**ADDENDUM NO. 2**  
**TO**  
**LIONS DEN ROAD – PHASE 3 RECONSTRUCTION**  
(300 feet north of Binning Road to approximately 250 feet south of the present Living Well entrance)

**COUNTY OF JEFFERSON, MISSOURI**

**APRIL 7, 2010**

END BENT NO. 1 DETAILS

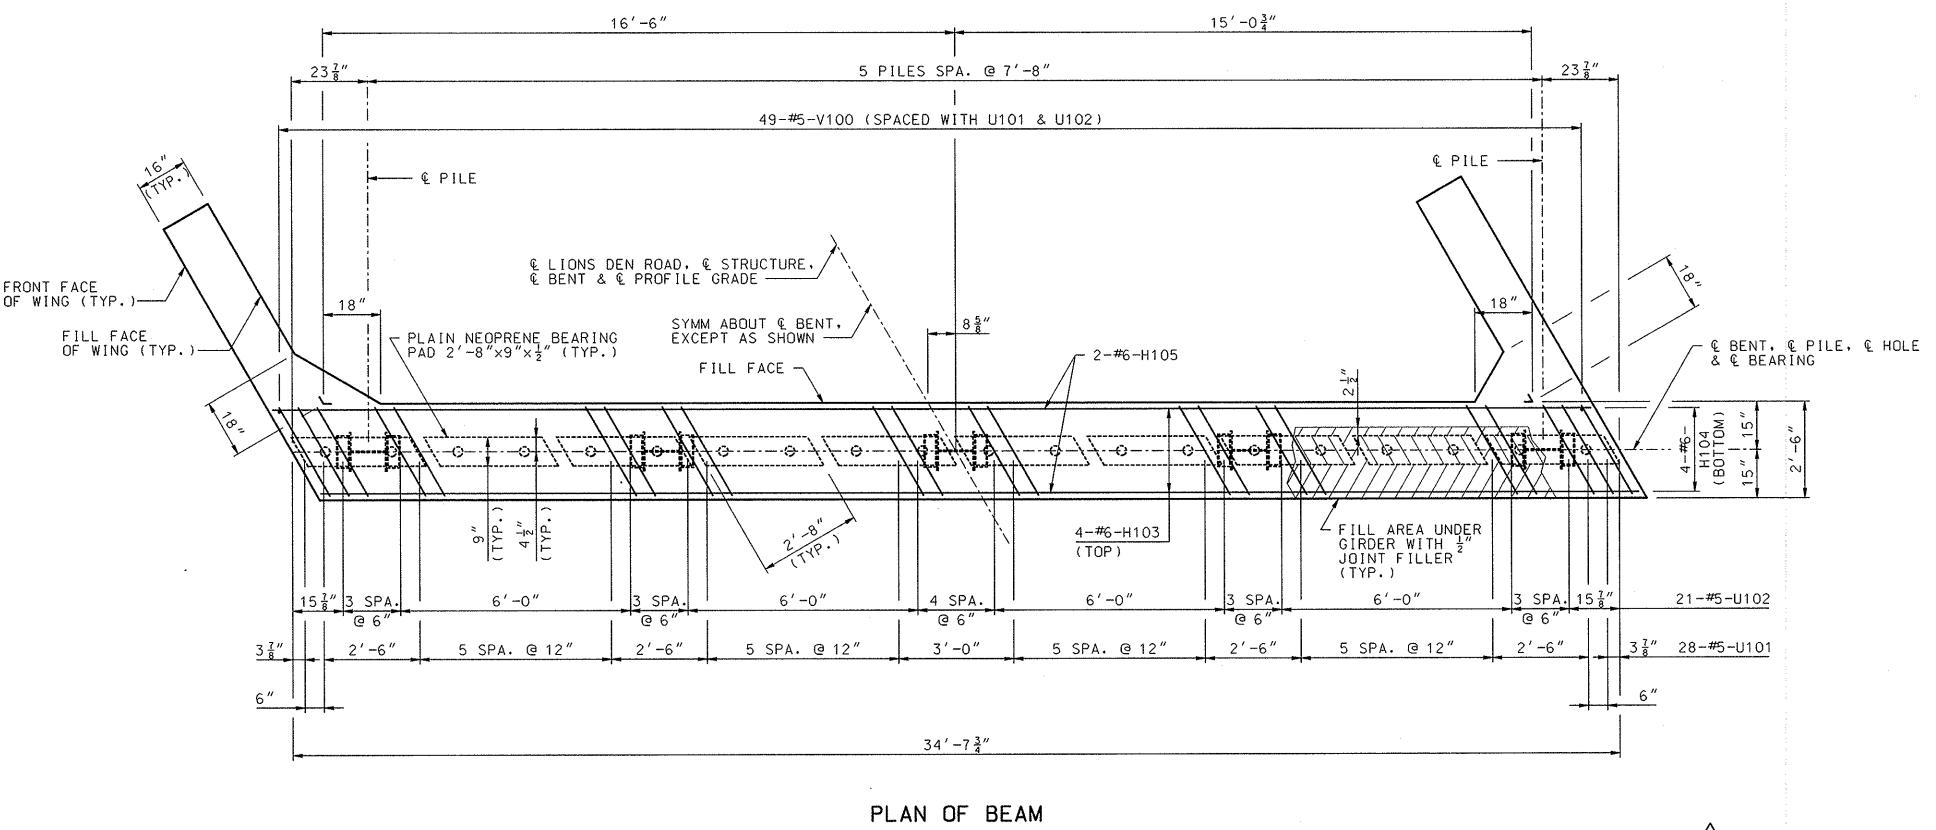
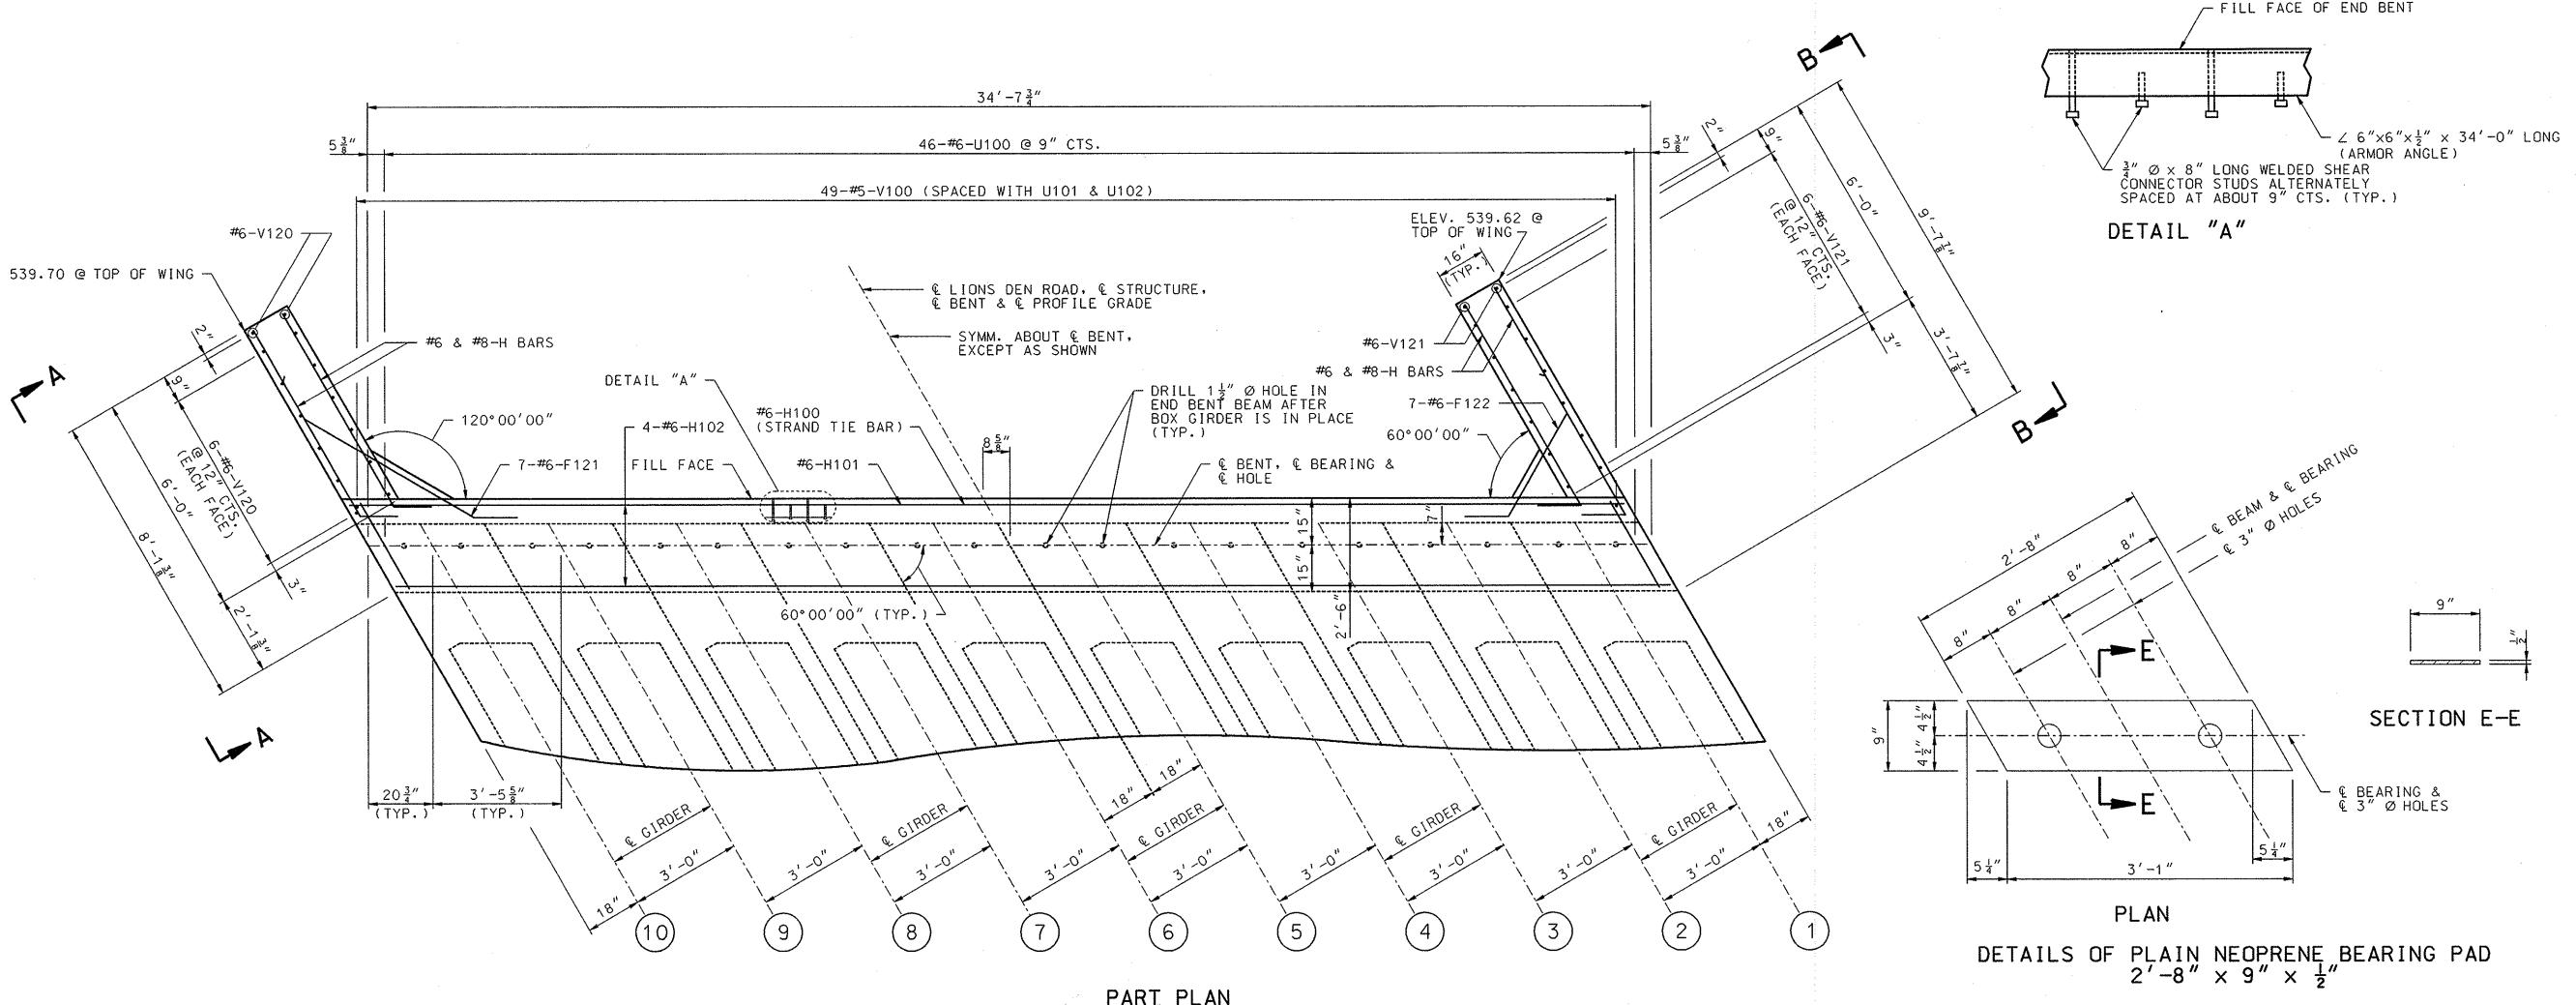
Remove plan sheets 59, 60, 63 and 64 and replace with revised plan sheets 59, 60, 63 and 64 dated 3-25-10.

- Provided quantity of CLASS A EXCAVATION to construct channel at new bridge location.
- Added note that the earth work quantities are based on the pavement structure shown in the TYPICAL SECTIONS.
- Deleted the note on all sheets concerning the pouring procedures of the concrete backwall.
- Corrected the piling quantity for Bent No. 2 on plan sheet 64 (total quantity of both bents is still correct).
